Swanwick Airspace Improvement Programme
Airspace Development 5
Proposed changes to LAC West to improve ATS route connectivity

SAIP AD5
Documentation:
Stage 4 Update and Submit

Step 4A Update Design

Figure 1 CAS arrangements in vicinity of MOSUN and OKTAD (L as consulted, R as proposed)

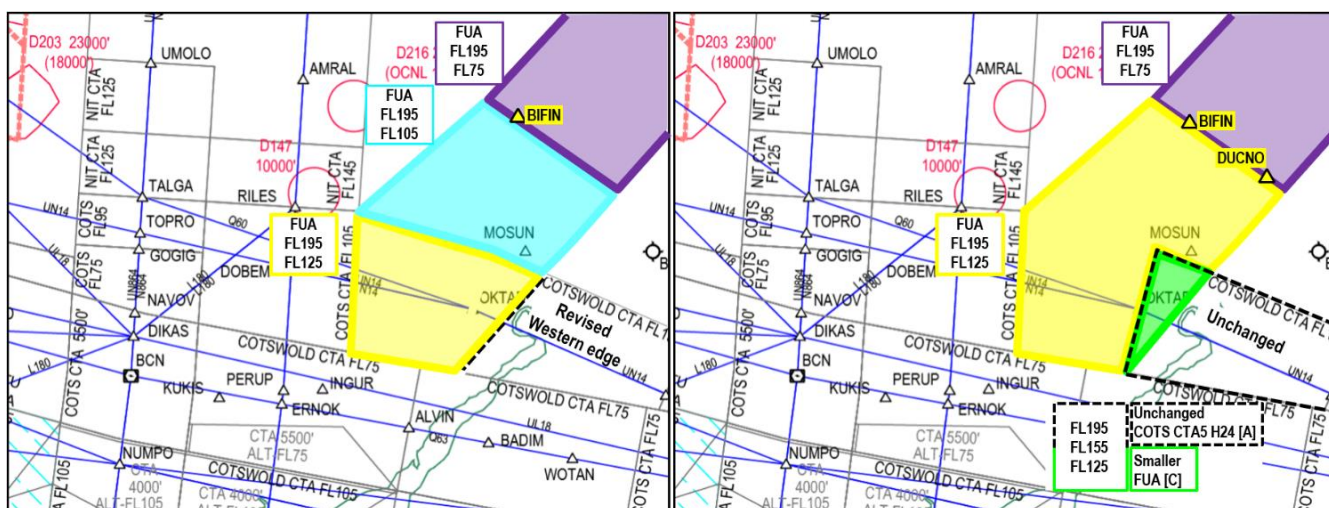
- 3.1 **Redefinition of FUA and H24 CAS in the vicinity of MOSUN/OKTAD, new base level change waypoint.**
See consultation document Figures 2, 6 and 7 and Element 10 above, regarding combining the blue volume into a larger yellow volume.

We originally proposed amending the western boundary of Cotswold CTA5 (Class A H24 FL155-FL195).

We now propose retaining the current dimensions of Cotswold CTA5, "fitting" the equivalent FUA volumes around and beneath ("new" light green volume in place of part of the consulted-upon yellow volume).

This would have the same overall lateral and vertical dimensions as the consulted upon volumes in the vicinity of OKTAD and west, with the MOSUN region having an FUA CAS base 2,000ft higher than consulted upon, reducing impact on other airspace users such as MoD and GA.

At the same time, we identified the need for an additional waypoint at the base level change between the two volumes (shown as DUCNO in the right hand chart). This was already covered in the consultation Section 7 Annex A where additional waypoints could be added for data transfer, flight-strip production and other administrative/technical reasons such as this.

Birmingham Airport has agreed to the raising of this CAS base, provided their arrivals descend to FL130 by waypoint BIFIN. Departures would be above FL130 by the base level change point DUCNO.

Figure 2 Consulted SEMMU placement (top), Proposed (above)

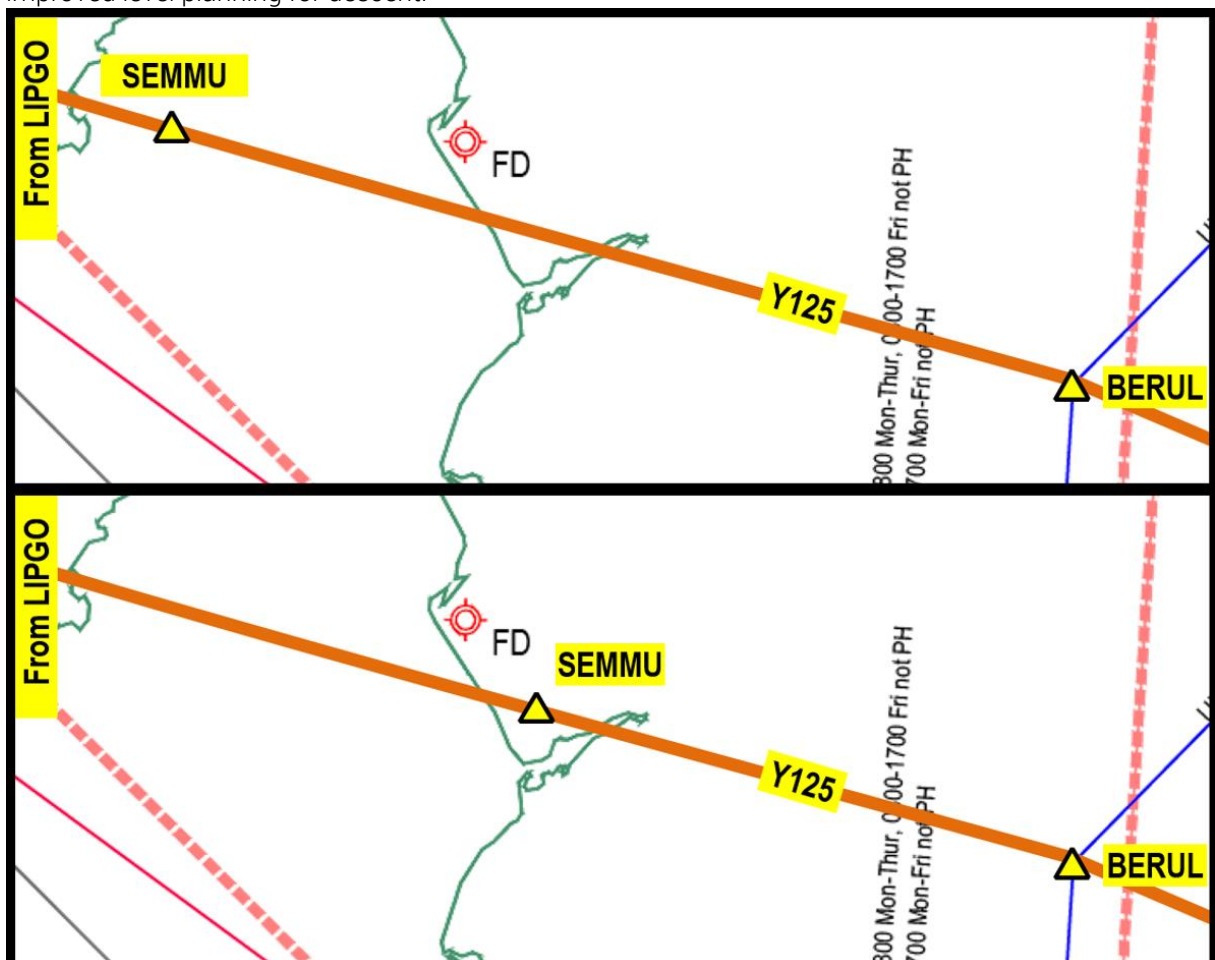
We reviewed the waypoint placements and found that waypoint SEMMU would be better placed further east along the proposed Heathrow offload route Y125 between LIPGO and BERUL, in order to provide improved level planning for descent.

Figure 3 Amendment to Birmingham STAR FIGZI 1B, corrected depiction of low level departure routes

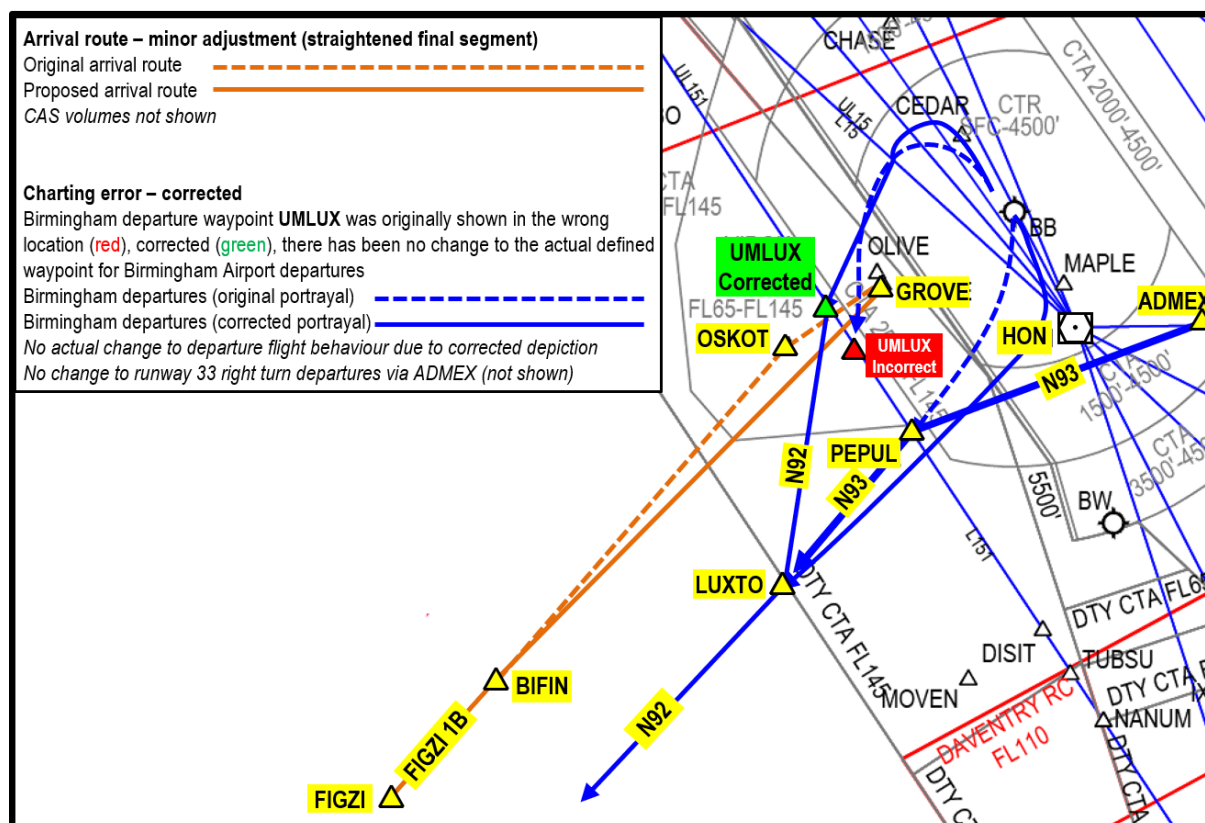
In the consultation document, the STAR was originally proposed to route FIGZI BIFIN OSKOT GROVE (see consultation document Figures 2, 6 and 7 and clarifying Figure 3 below).

We now propose to remove the slight dogleg at OSKOT, routing FIGZI BIFIN GROVE. Technically, the removal of the dogleg shortens the route by a fraction and also allows for a reduction in the CAS required to contain the STAR, both of which are advantages (reduced impacts on other airspace users) but negligible in practice. The practical advantages, albeit small, are that the final track before the GROVE hold would become a simple 28nm long straight segment, and the CAS boundary lateral dimensions become slightly less complex at the northern vertex west of OSKOT (see CAS chart for the region, Figure 4 on page 10 below).

On the same chart below we have corrected the depiction of low-level Birmingham departures. We originally showed Birmingham's departure waypoint UMLUX in the wrong place in the consultation material, leading to differences in the illustrated departure routes- we apologise for this. For the avoidance of doubt, this chart correction has **no impact on actual flight behaviours** at low level. This proposal continues to align with Birmingham Airport's own current and proposed departure procedures. Those procedures are managed by Birmingham Airport and regulated/published by the CAA.

Figure 4 Consulted (left) and Proposed (right) CAS volumes near Birmingham

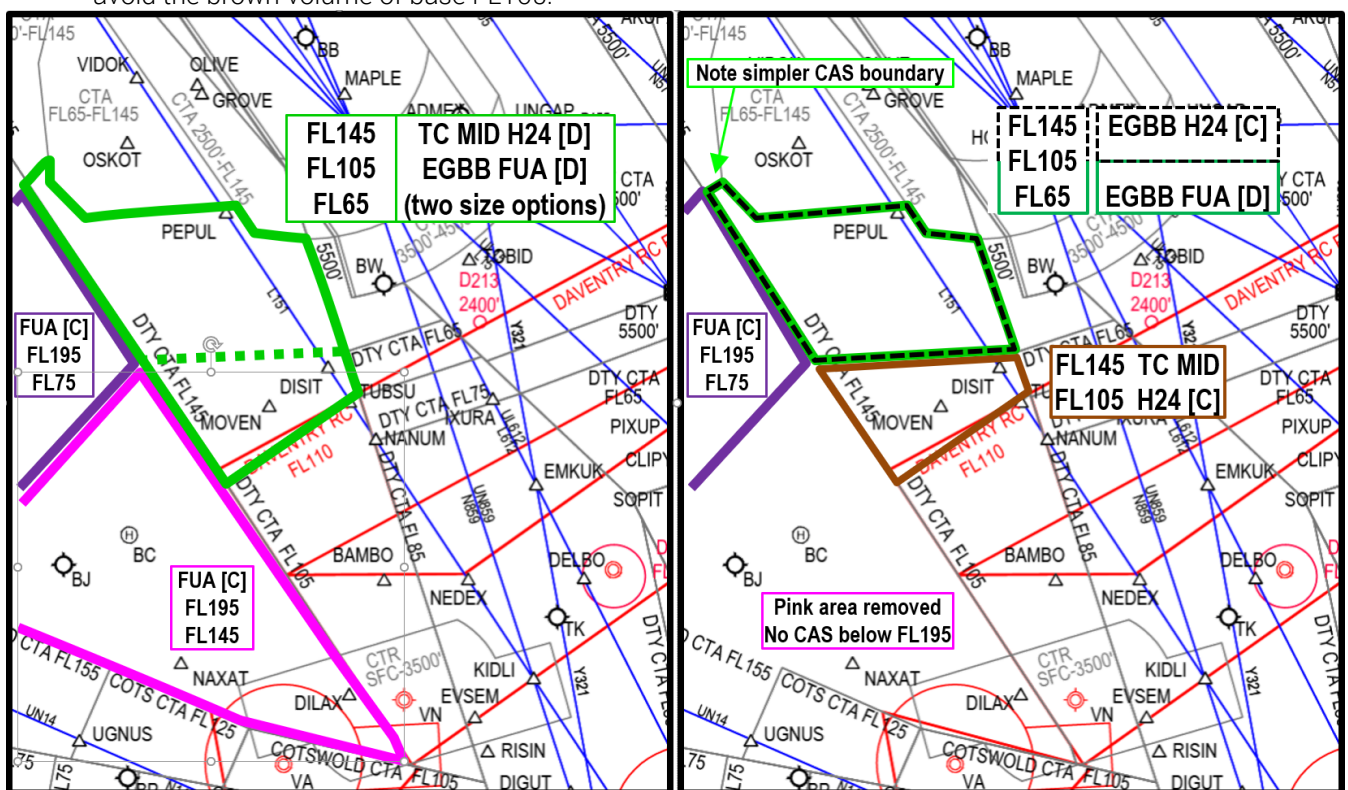
In the consultation we illustrated two options for CAS in the vicinity of Birmingham, Figures 1 and 6 showed Option 1 (larger volume depicted in green), Figures 2 and 7 showed Option 2 (smaller volume). Feedback Element 1 summarised Birmingham Airport's preference for Option 1's larger volume, this was also NATS' stated preference. Feedback Element 9 summarised the MoD's preference for Option 2's smaller volume, their requirement for Class C in the airspace abutting the DTY Radar Corridor, and their requirement for that Class C airspace to not be delegated to another party. (The MoD's requirements are based on RAF(U)'s standard operations where they may operate without coordination in Swanwick-operated Class C.)

NATS proposes to compromise by establishing the Option 2 volumes near Birmingham and another volume, with a higher CAS base matching Option 1, abutting to the south. This provides the best of both worlds, where Birmingham can use the main area (green FUA Class D and black H24 Class C), Swanwick TC the brown area (H24 Class C), and the MoD could fly through the brown area without coordination as per standard Swanwick RAF(U) operations. DTY Corridor transits at FL100 would also avoid the brown volume of base FL105.

We explored these elements and can remove the southern pink volume from the proposal. This is consistent with DP5 (minimise negative impact on other airspace users).

As per para 3.3 on page 8, the right hand chart above highlights the slight reduction in CAS complexity at the northern vertex, also consistent with DP5.
